Engineering Department Land Use Application Review Comments & Conditions

To: Joy Chang, Associate Planner, Planning Department
From: Bob Galati P.E., City Engineer, Engineering Department
Project: Middlebrook Subdivision (SUB 18-02)
Date: June 26, 2019

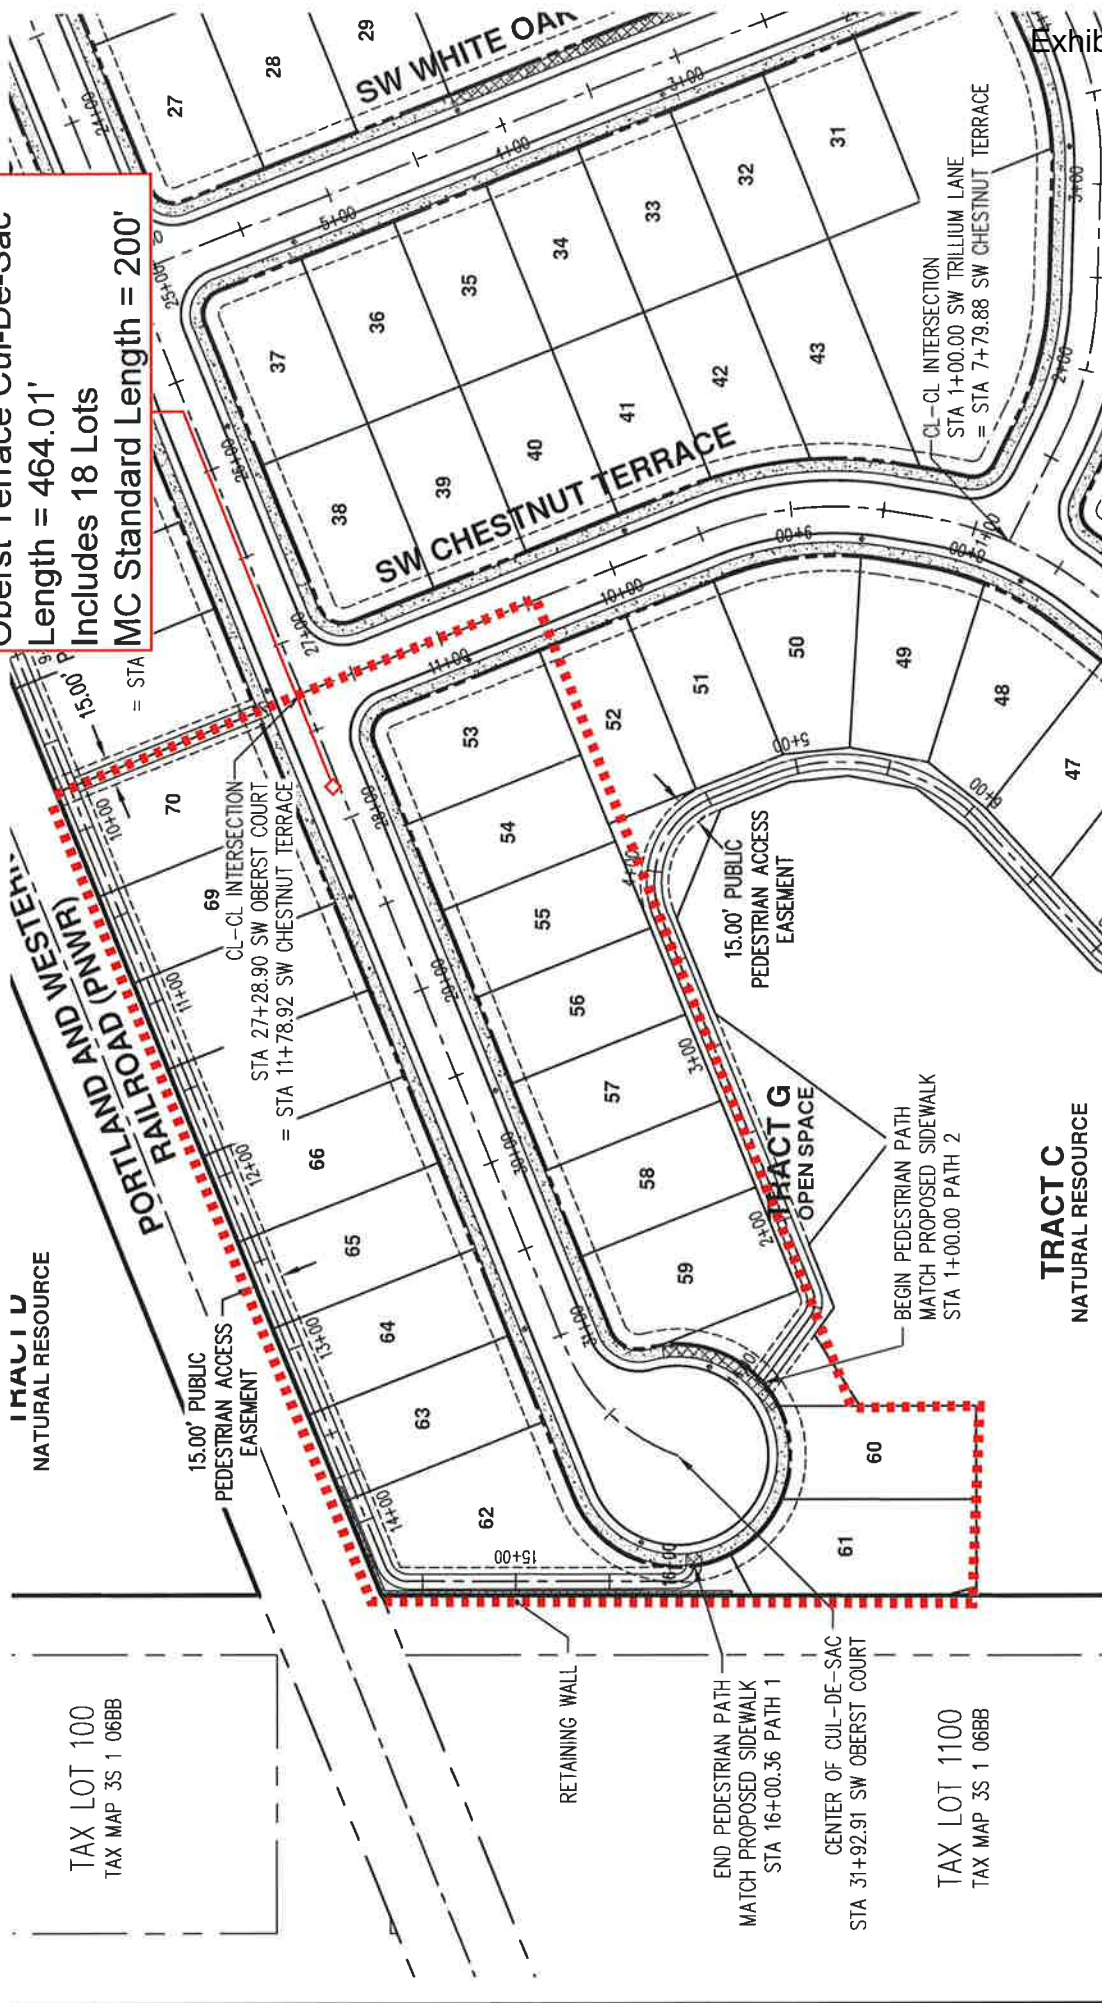
The proposed design length of the Oberst Court cul-de-sac is shown as being 464.01 feet in length, with a total of 18 SFR dwelling units taking access off the cul-de-sac.

Based on this analysis, the request for a cul-de-sac length in exceedance of MC Section 16.106.040.E.1 is **approved**.
